IN REPLY REFER TO:
NCPC File No. Z.C. 07-27

**CONSOLIDATED PLANNED UNIT DEVELOPMENT AND MAP AMENDMENT
ST. PAUL'S COLLEGE**

3015 4th Street, NE
Washington, D.C.

Delegated Action of the Executive Director

Illustrative Site Plan

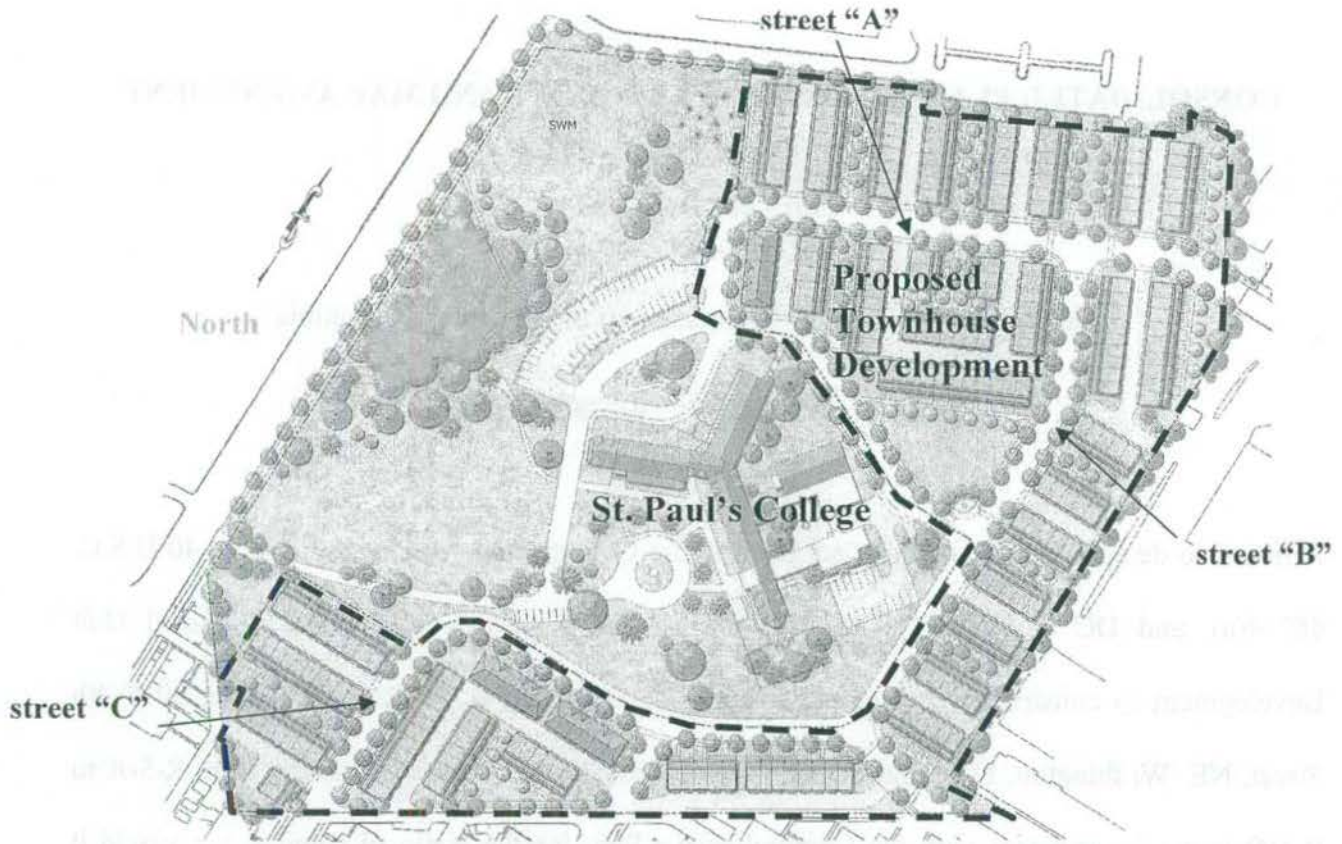
Staff notes that an unimproved public street right-of-way is located along the southern portion of this site. As the development includes the construction of townhouses overtop of this unimproved street right-of-way, the right-of-way needs to be closed through the Highway Plan amendment process. All Highway Plan amendments are required to be referred to NCPC for approval prior to District of Columbia City Council adoption.
